Preliminary Consultation
MONTGOMERY COUNTY HISTORIC PRESERVATION COMMISSION
STAFF REPORT

Address:	4023 Jones Bridge Rd., Chevy Chase	Meeting Date:	10/23/2024
Resource:	Master Plan Site #35/56 Hurley/Sutton House	Report Date:	10/16/2024
Applicant:	Tatyana Baytler	Public Notice:	10/9/2024
Review:	Preliminary Consultation	Staff:	Dan Bruechert
PROPOSAL:	New Garage and Deck Construction

Figure 3: Massing study of the proposed garage and deck covering/enclosure.

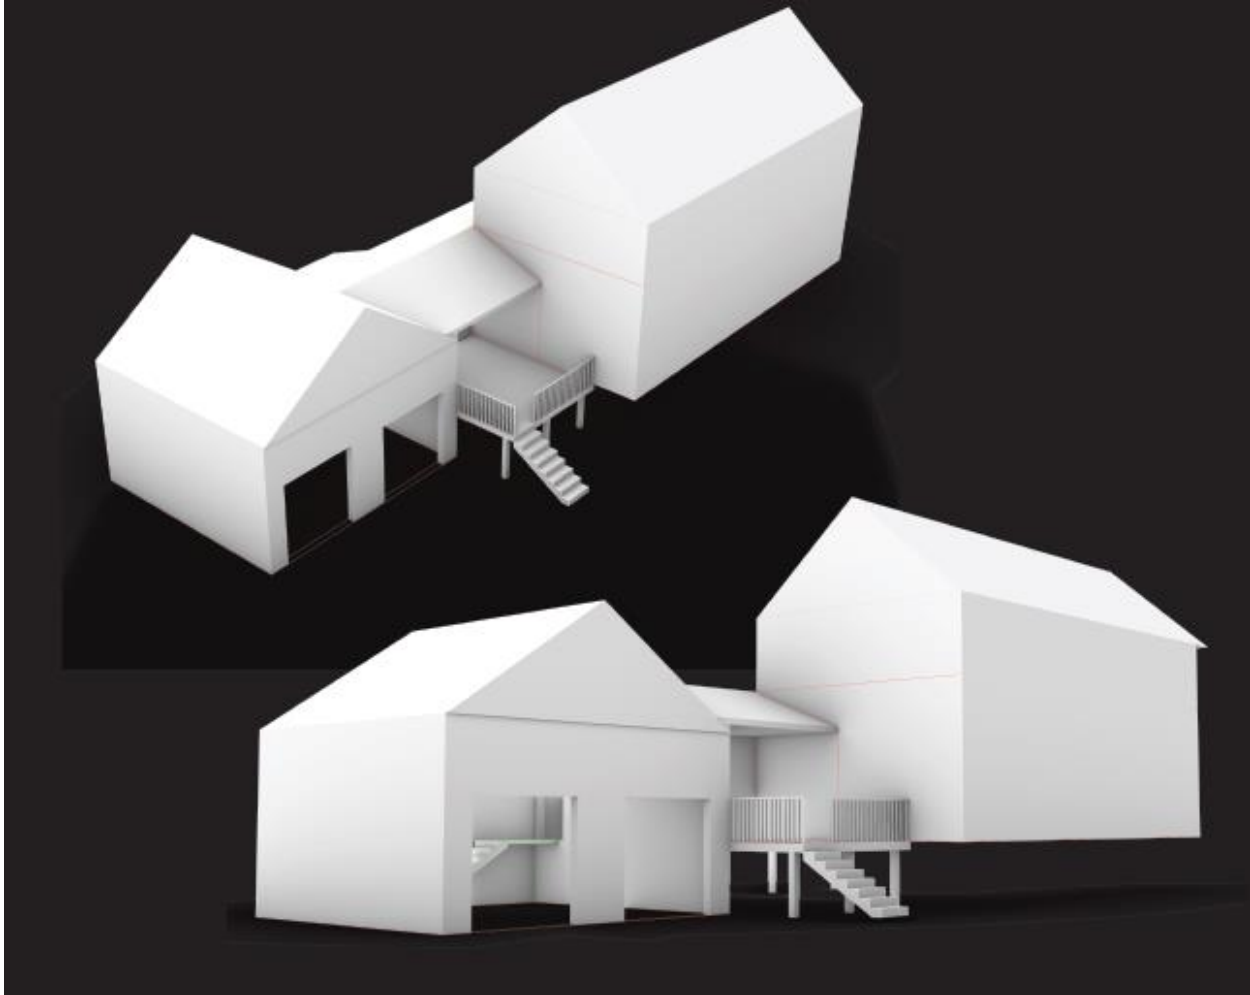
Based on the massing study provided, Staff finds the garage is likely too close to the house to be compatible. The placement of the garage is only 12' (twelve feet) and its massing is so large that it visually competes with the historic house. Because of the change in grade, the garage appears to be half a story lower, which does help to reduce the visual impact of the garage's perceived mass.

Staff finds the parcel is big enough that a large garage could be constructed on the property without detracting from the Master Plan Site's historic character; however the applicant should consider other locations further from the house. Placing the garage further from the historic house would also lower its height in comparison to the historic house due to the change in grade.

Figure 4: Massing study from the southeast of the house.

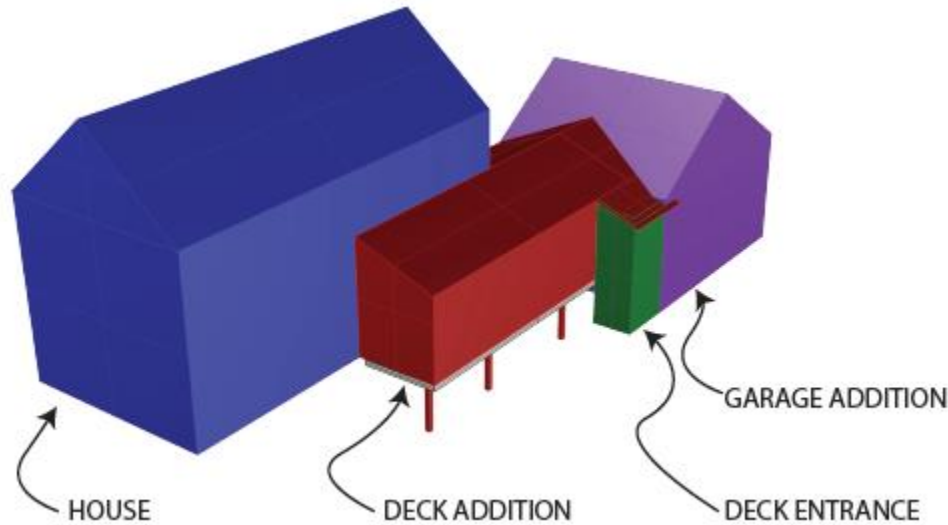
Staff finds the modifications to the porch are out of character with the design and time period of the subject property. This house would have stood apart from any accessory buildings. Connecting the house to the garage, effectively creating an attached garage is a feature more associated with mid-20th century architecture.

Staff acknowledges that much of the proposed roofing will not attach to the house's historic fabric. However, the guidance provided in 24A focuses on preserving the architectural character of the resource rather than encasing a historic resource in amber. Staff, and the HPC, found that the rear addition was compatible with the character of the site in 2020. Staff find the proposal to attach the garage with roofing alters the massing to a degree that it would contravene 24A-8(b)(1) and (2) and Standard 9.

Staff additionally finds that enclosing the portion of the deck along the right side of the house would negatively alter the massing of the historic house. The simple, narrow, front-gable house form were specifically identified in the Master Plan Amendment that created the Hurley/Sutton House Master Plan site. If the objective is to create additional space for an office, as labeled in the drawings, or some other function, it could be possible to incorporate that function into a new detached garage, provided its location is appropriate. Staff would not support enclosing this portion of the deck, because of the significant impact it would have on the house massing.
